COUNCIL ASSESSMENT REPORT

HUNTER AND CENTRAL COAST REGIONAL PLANNING PANEL

PANEL REFERENCE & DA NUMBER	PPSHCC-159 – DA2022-01316
PROPOSAL	DA2022-01316 - Stage 1 involving demolition of existing structures and the erection of a mixed use development proposing 136 apartments, retail premises and associated parking, landscaping, services and associated two lot subdivision.
ADDRESS	Lot 1 DP 867617 - 711 Hunter Street Newcastle West
APPLICANT	Urbis Pty Ltd
OWNER	Hunter Street JV CO Pty Ltd
DA LODGEMENT DATE	17/11/2022
APPLICATION TYPE	Development Application
REGIONALLY SIGNIFICANT CRITERIA	Section 2.19(1) and Clause 2 of Schedule 6 of State Environmental Planning Policy (Planning Systems) 2021 declares the proposal regionally significant development as: Development that has a capital investment value of more than \$30 million.
CIV	\$65,382,029.00 (excluding GST)
CLAUSE 4.6 REQUESTS	<ul style="list-style-type: none"> • C14.4 – Floor Space Ratio NLEP 2012 • C17.4 – Building Separation NLEP 2012

DRAFT CONDITIONS TO APPLICANT	No
SCHEDULED MEETING DATE	27 July 2023
PREPARED BY	Damian Jaeger
DATE OF REPORT	20 July 2023

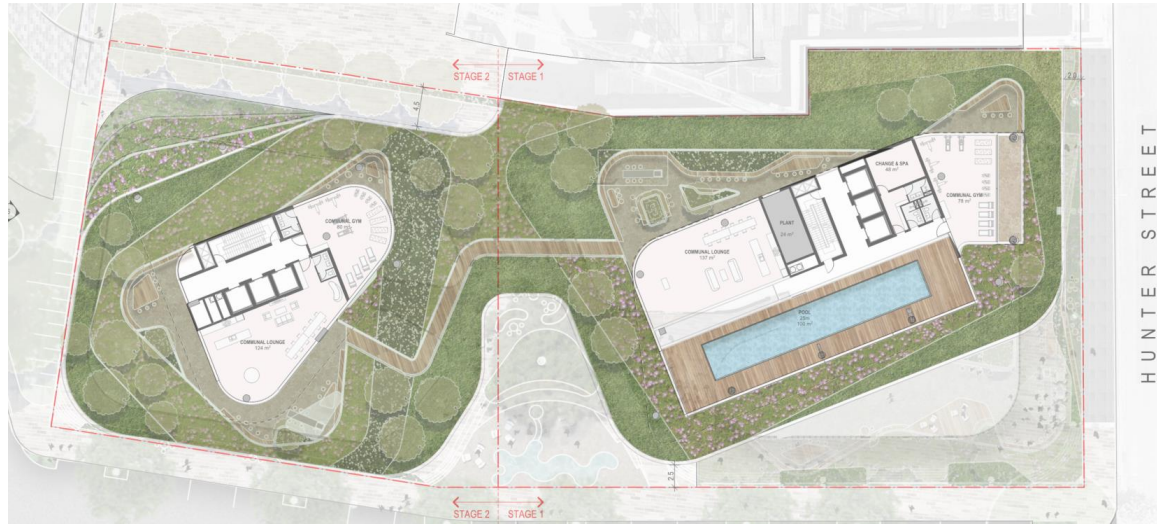
While there has been some increases in the planted areas outside bedroom windows that can act as a setback from communal spaces, this separation remains less than desirable for achieving reasonable levels of privacy. This should be reconsidered as part of the recommended overall increase in soft landscape area on the podium in lieu of synthetic turf and some hard paving.

The proposed amended design, as reviewed by the UDRP, has not been further revised by the applicants to resolve the issues associated within the proposed landscaping design, synthetic turf and the design layout in terms of the ratio of communal open space to private open space.

A condition of consent on a deferred commencement basis is recommended at **Attachment A**, requiring that the ratio of communal open space to be increased when compared to private open space for the dwellings on this level podium. The additional communal open space area is to incorporate additional landscape plantings.
